**Clinton Power Station**

RS-03-060

Clinton Power Station, Unit 1  
Facility Operating License No. NPF-62  
NRC Docket No. 50-461

Subject: Request for License Amendment Related to Application of Alternative Source Term

Figure 1

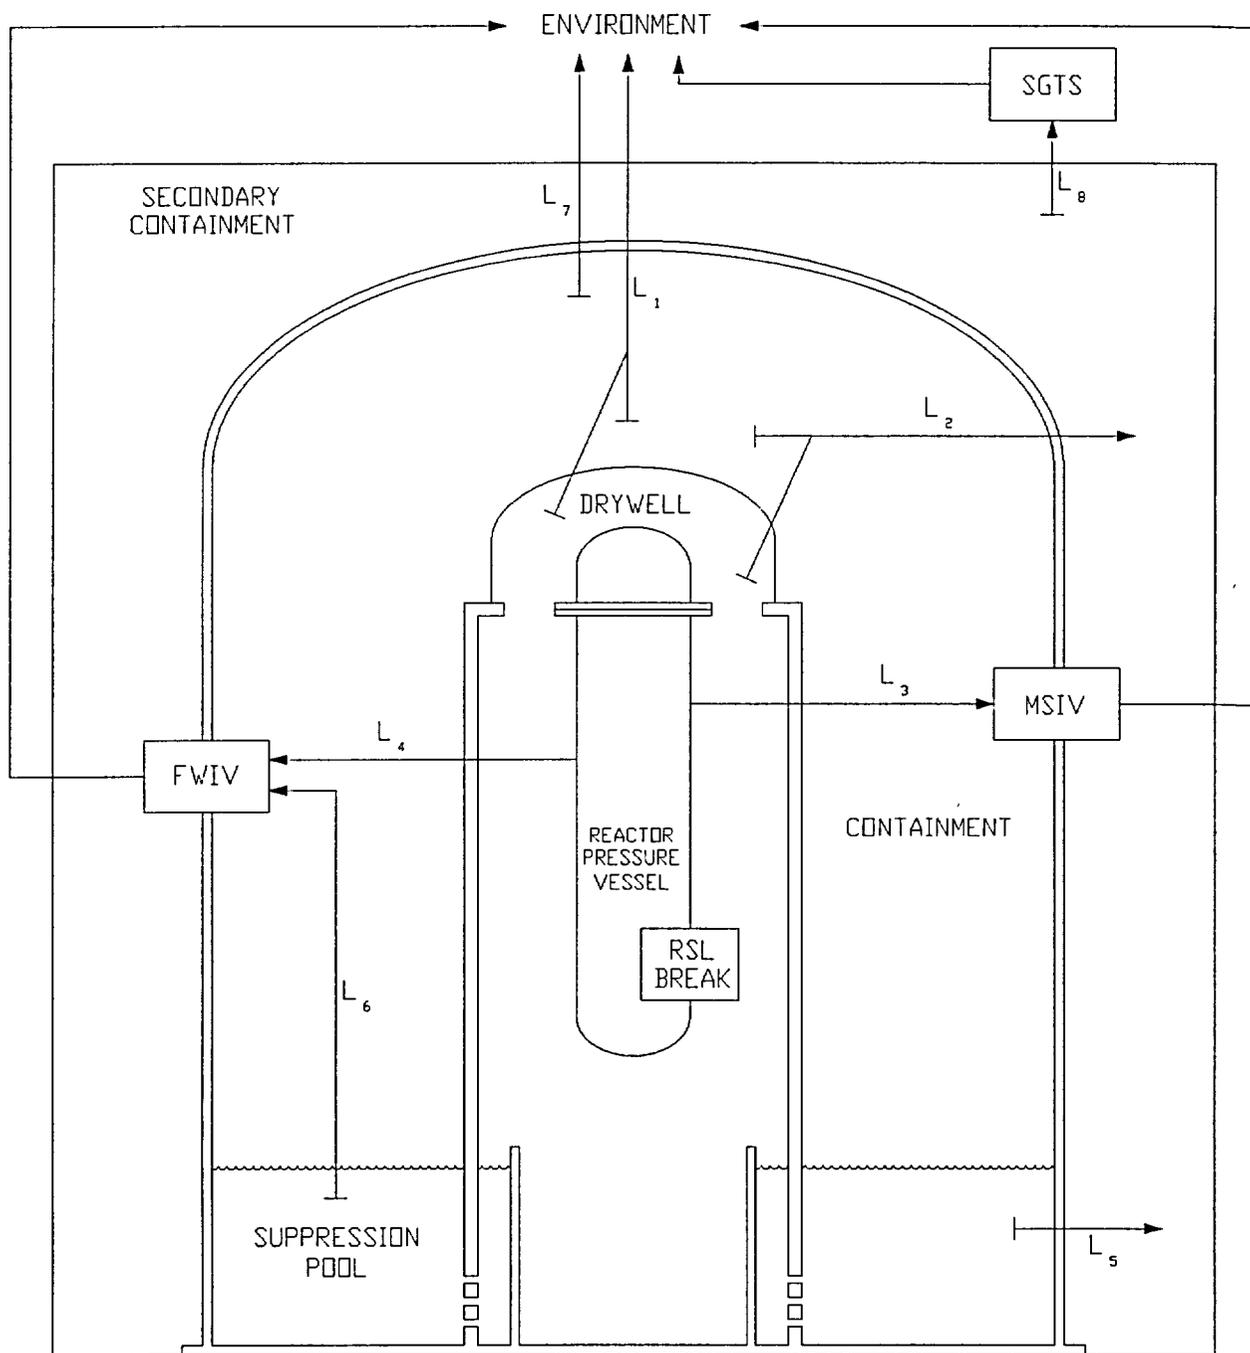
Figure 1 illustrates the LOCA release pathways, with its associated Table of leakage parameters. Figure 2 illustrates the radiological release and control room intake pathways utilized.
